CHRYSLER A604 (41TE) UPDATE HANDBOOK

*Updated
May, 2003*

"UPDATE HANDBOOK"

Figure 66

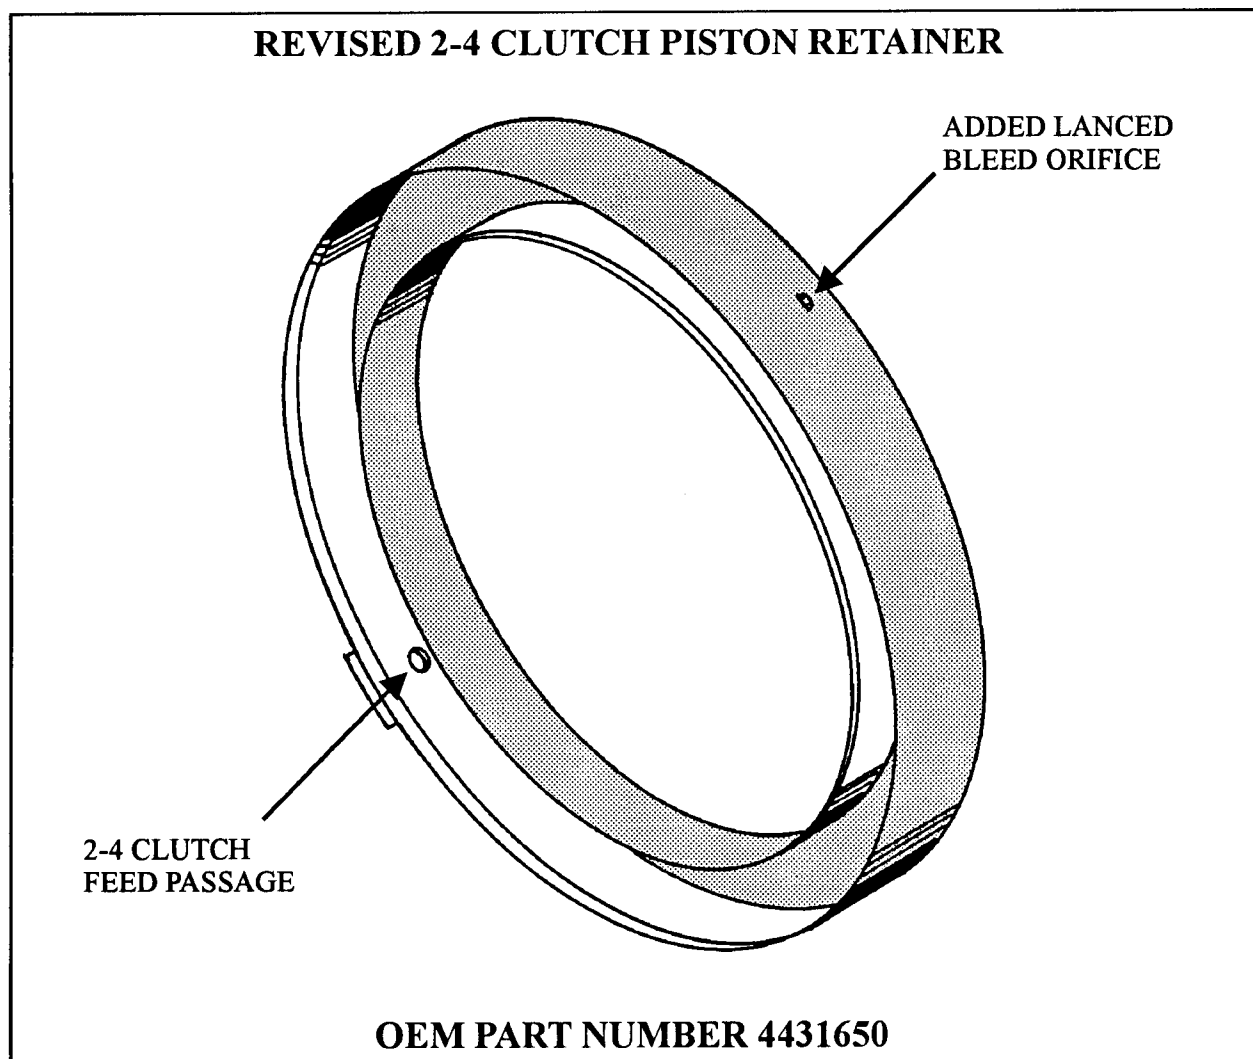
CHANGE: Beginning at the start of production for the 1995 model year, all Chrysler A604 (41TE) and A606 (42LE) transaxles were produced using a revised 2-4 Clutch Piston Retainer with an added lanced bleed orifice (See Figure 66).

- (1) 2-4 CLUTCH PISTON RETAINER - Lanced bleed orifice added to the retainer in the location shown in Figure 66.

The revised 2-4 Clutch Piston Retainer with the added lanced bleed orifice will back service ALL previous models of Chrysler A606 (41TE) and A606 (42LE) transaxles. There was not a part number change, so the revised retainer is available under OEM part number 4431650.

Figure 73

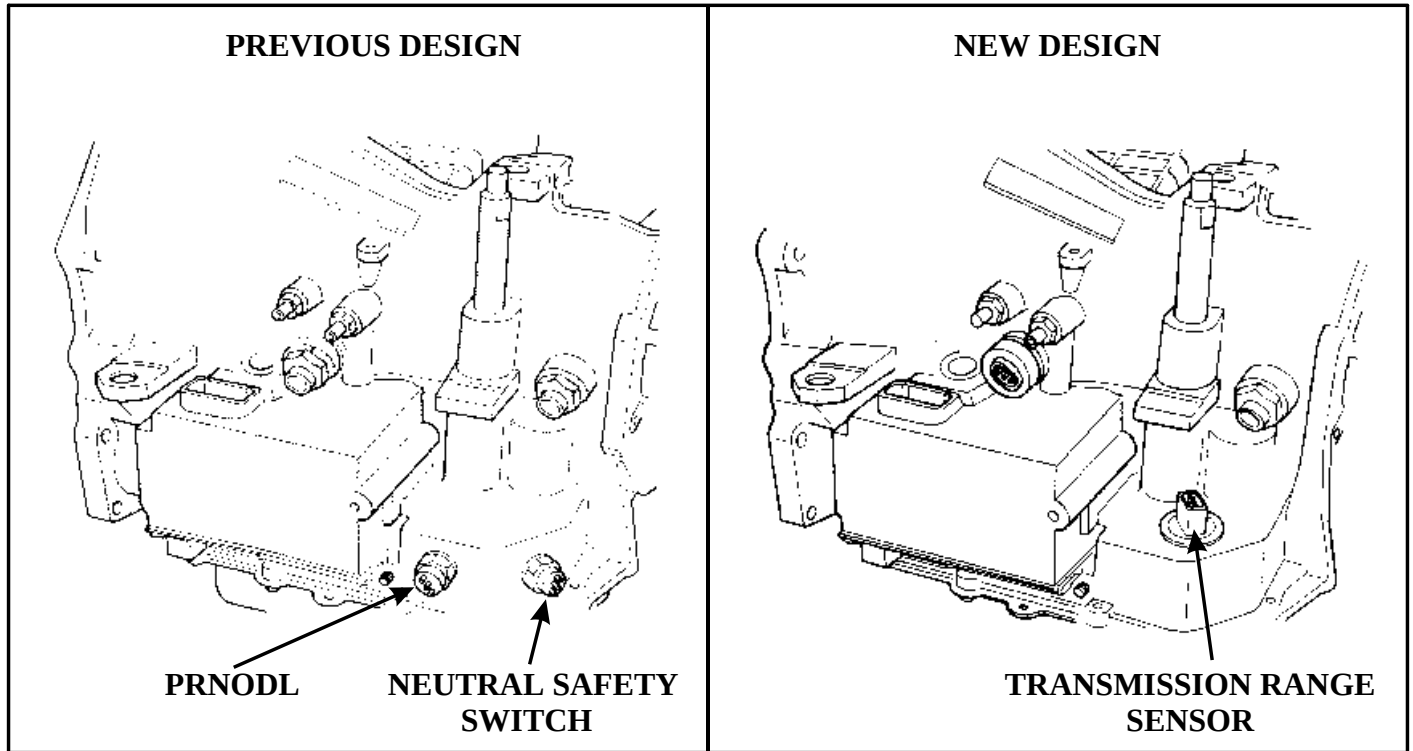
CHANGE: Beginning at the start of production 1996, some models equipped with the 41TE (A604) transaxle replaced the PRNODL and Neutral Safety Switch with a Transmission Range Sensor as seen in Figure 73.

- (1) PRNODL SWITCH - The previously used Park, Reverse, Neutral, Overdrive, Drive, Low Switch (PRNODL) has been eliminated and replaced with the new Transmission Range Sensor (See Figure 73).

- (2) NEUTRAL SWITCH - The previously used Neutral Switch has been eliminated and replaced with the new Transmission Range Sensor (See Figure 73).
- (3) TRANSAXLE CASE - The casting of the case change with the elimination of the two threaded holes for the PRNODL and Neutral Safety Switch. An access hole has been added to accommodate the new TRS sensor connector as the switch which is mounted on the valve body (See Figure 73).

Figure 74

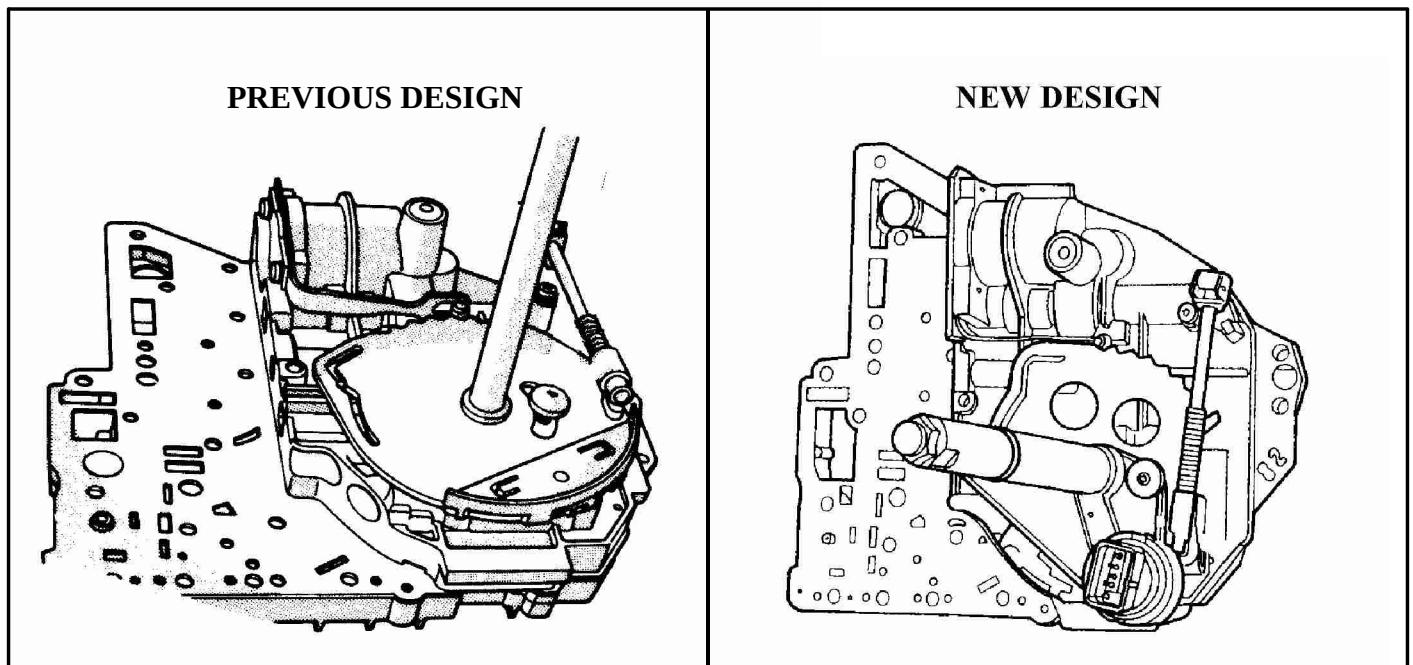
- (4) VALVE BODY - The manual arm shaft and rooster comb assembly and the valve body changed in design to accommodate the mounting of the new TRS sensor (See Figure 74).

Figure 77

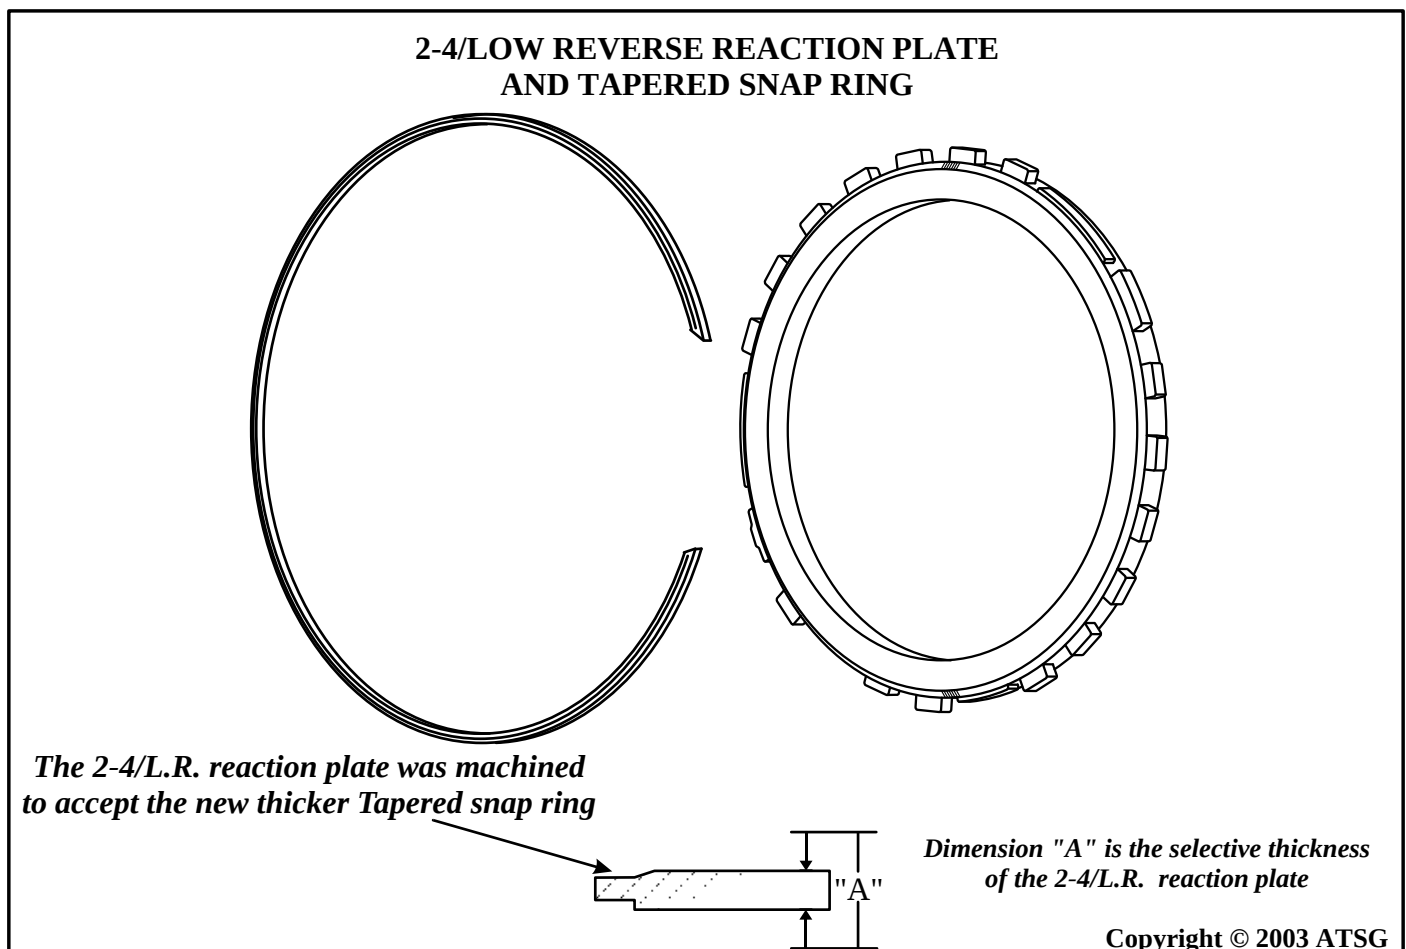
CHANGE: Some time in 1999, four of the previous 2-4/Low Reverse Reaction Plate selectives were changed to accommodate a new Tapered Snap Ring as shown in Figure 77.

NOTE: *The thicker tapered snap ring is included in the new 2-4/Low Reverse Reaction Plate package when the Part Number ends with "AA."*
